9.5 Other Auxiliary Systems

The information in this section of the reference ABWR DCD, including all subsections, tables, and figures, as modified by the STP Nuclear Operating Company Application to Amend the Design Certification rule for the U.S. Advanced Boiling Water Reactor (ABWR), "ABWR STP Aircraft Impact Assessment (AIA) Amendment Revision 3," dated September 23, 2010 is incorporated by reference with the following departures and supplements.

STD DEP T1 3.4-1	STD DEP 9.5-2 (Figure 9.5-3, replaced entire figure)
STP DEP 1.1-2 (Figures 9.5-2, 9.5-4 and 9.5-5)	STD DEP 9.5-3
STP DEP 1.2-2 (Table 9.5-5)	STD DEP 9.5-4
STD DEP 8.3-1	STP DEP 9.5-6 (Figure 9.5-6)
STD DEP 9.4-2 (Table 9.5-5)	STP DEP 9.5-7 (Table 9.5-5)
STD DEP 9.5-1	STD DEP Admin

Figure 9.5-2 Outline - Telephonic Communication System for Single Unit of STP 3 or 4

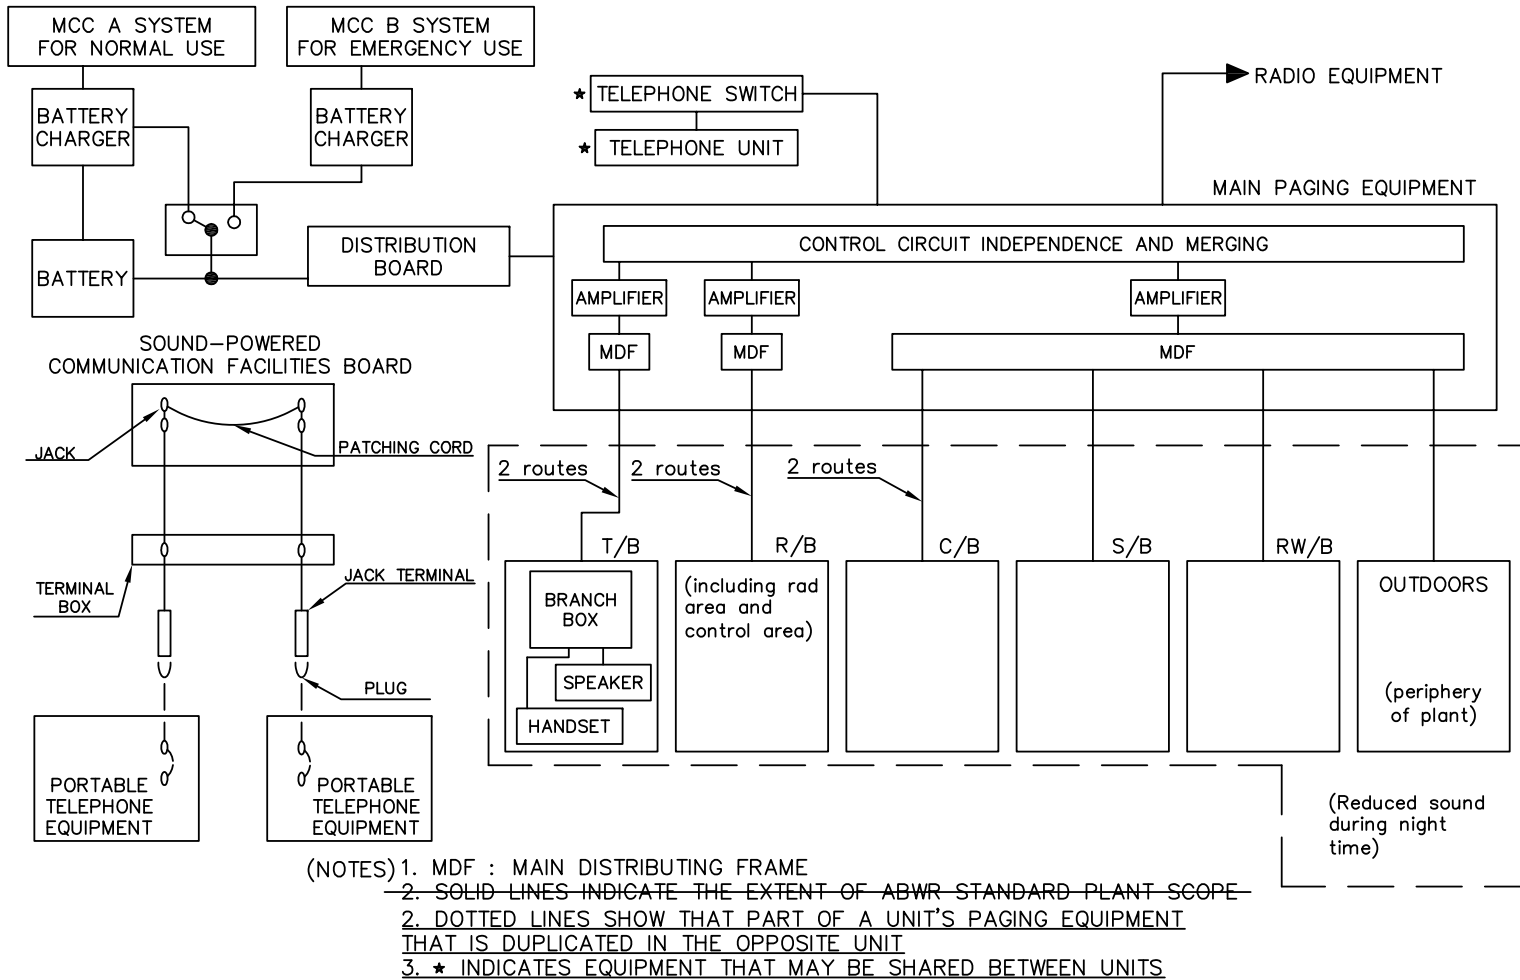
At STP 3 & 4, a common communication system is used to provide plant-wide communications between the dual units. The communication system is not safety-related. A common communication system providing plant wide communications is a safety enhancement since it allows for ease of communication between units. The representative outline of the common communication system is shown in Figure 9.5-2 for STP 3 & 4.

Figure 9.5-3 Lower Drywell Flooder System Arrangement/Configuration

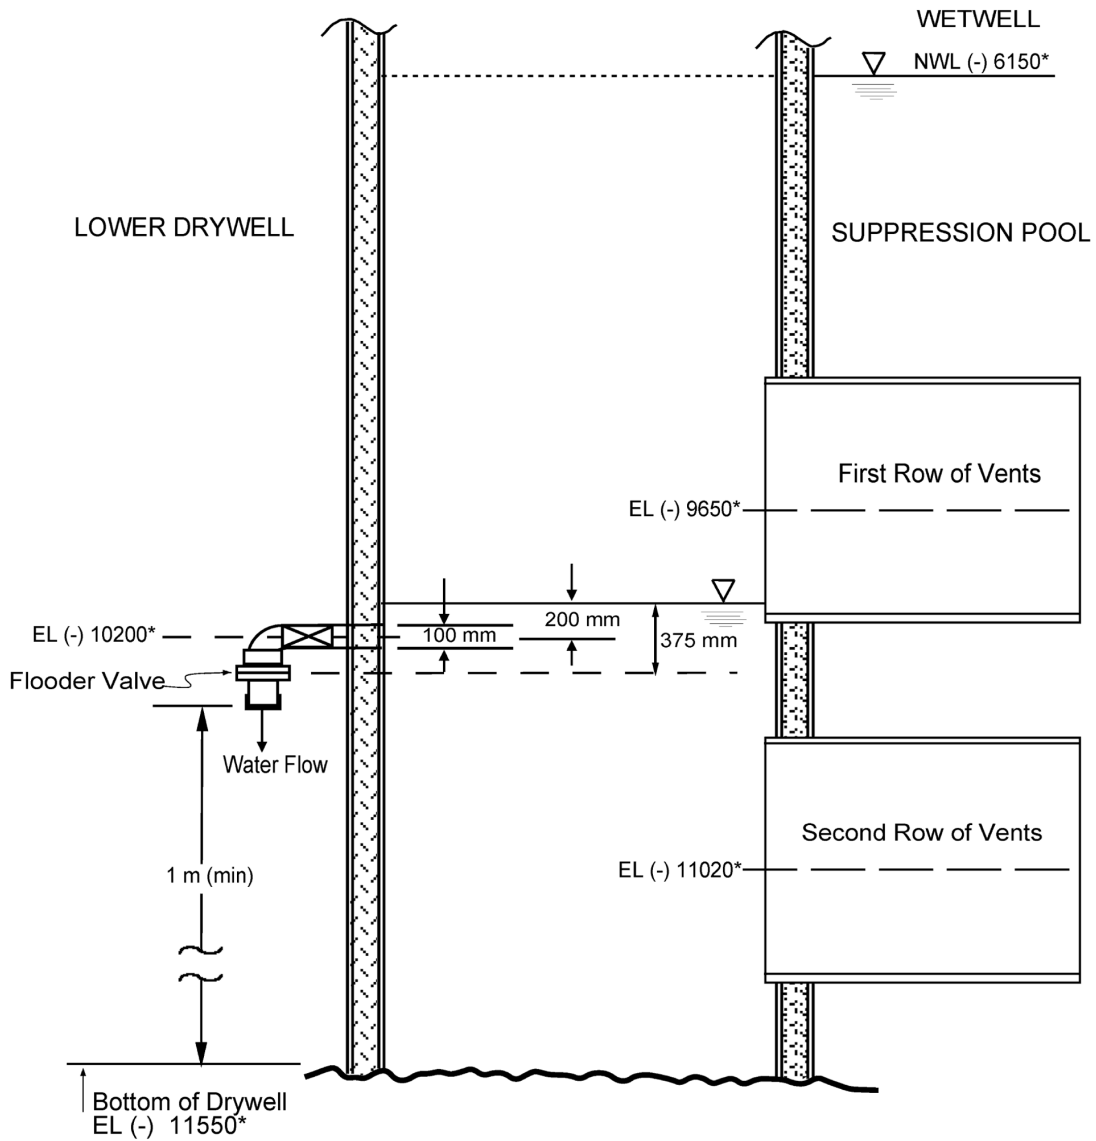
The LDF, shown schematically in Figure 9.5-3, provides a flow path for suppression pool water into the lower drywell area during severe accident scenario that leads to core meltdown, vessel failure, and deposition of molten corium on the lower drywell floor. Molten corium is a molten mixture of fuel, reactor internals, the vessel bottom head and control rod drive components. The flow path is opened when the lower drywell airspace temperature reaches 260°C.

The LDF consists of ten pipes that run from the vertical pedestal vents into the lower drywell. Each pipe ~~contains~~ has an isolation valve and a fusible plug valve connected to the end of the pipe that extends into the lower drywell ~~by a flange~~. The fusible plug valves open when the drywell air space ~~(and subsequently the fusible plug)~~ temperature reaches 260°C. When the fusible plug valves open, a minimum of 10.5 L/s of suppression pool water will be supplied through each flooder pipe (105 L/s total) to the lower drywell to quench the corium, flood the lower drywell and remove corium decay heat, which is estimated at 1% of rated thermal power. The flow rate is based on a minimum hydrostatic head of 200 mm above the flooder pipe inlet centerline and takes the frictional losses through the flooder pipe and fusible plug valve into account.

Figure 9.5-4 Fire Protection Water Supply System

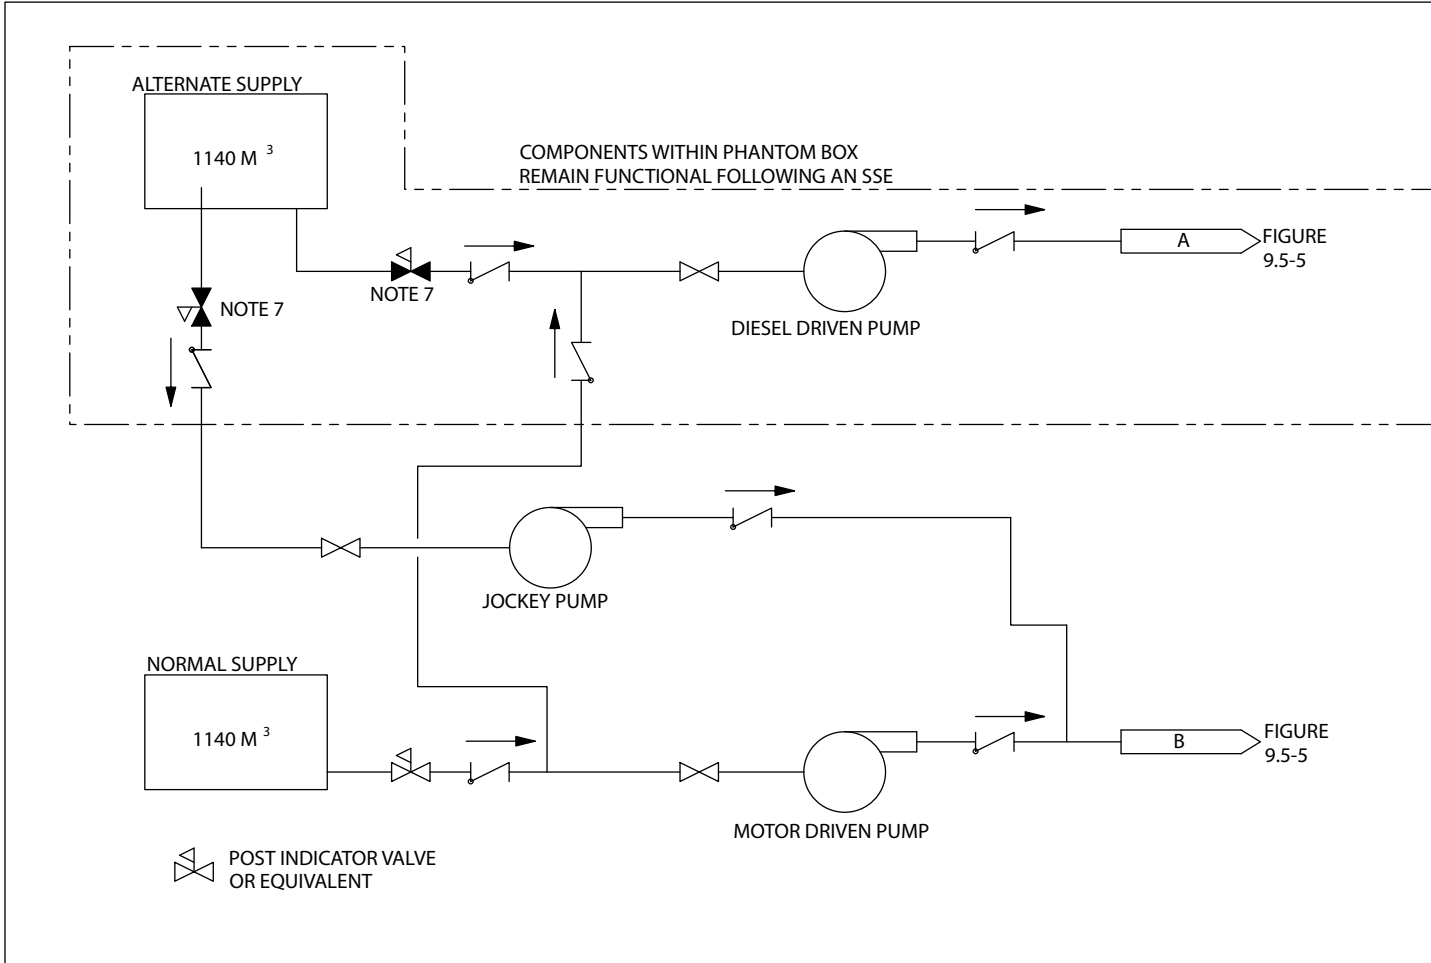
STP 3 & 4 is a dual-unit station. The water supply for fire protection will be shared by STP 3 & 4. A single fire protection pump house and two storage tanks are located within the protected area boundary that provides water for fire suppression to both units via piping in the yard. This common system has the same capability as the system for the single unit design. The fire protection water supply complies with Regulatory Guide 1.189, Rev. 1, which states that a common water supply may be utilized for multi-unit nuclear power plant sites with a common yard fire main loop. The common fire water supply and yard main piping system for STP Units 3 & 4 are depicted in Figures 9.5-4 and 9.5-5. The common yard fire main loop surrounding STP Units 3 & 4 is cross-connected between units in accordance with Regulatory Guide 1.189, Rev. 1.

Figure 9.5-5 Fire Protection Yard Main Piping

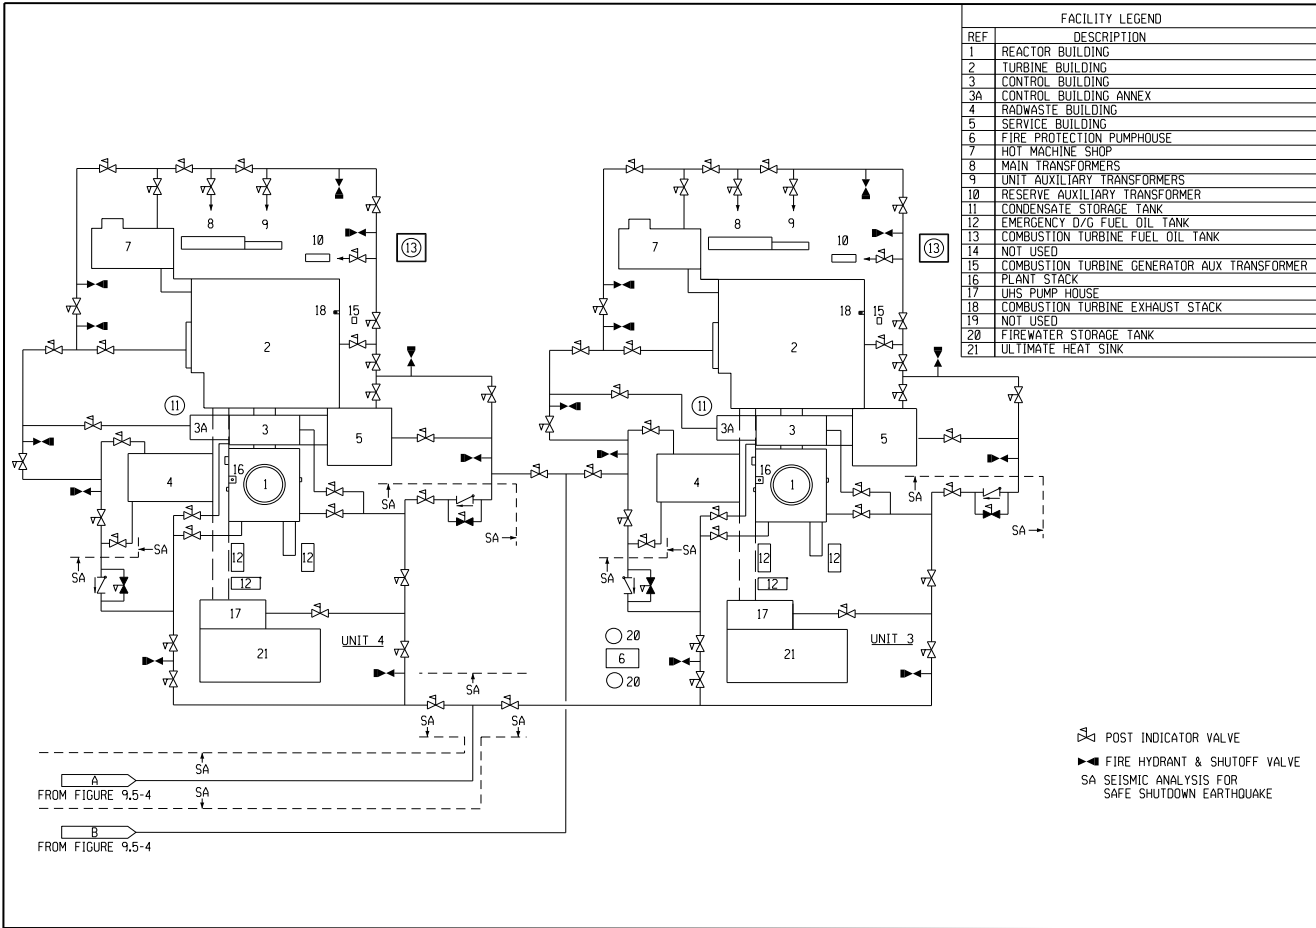
<i>Area</i>	<i>Figures</i>
<i>Reactor Building</i>	<i>9A.4-1 thru 9A.4-10</i>
<i>Control Building</i>	<i>9A.4-11 thru 9A.4-16</i>
<i>Turbine Building</i>	<i>9A.4-17 thru 9A.4-21, <u>9A.4-33 and 9A.4-34</u></i>
<i>Service Building</i>	<i>9A.4-22 thru 9A.4-27</i>
<i>Radwaste Building</i>	<i>9A.4-28 thru 9A.4-32</i>
<i>Plant Yard</i>	<i>9.5-5</i>
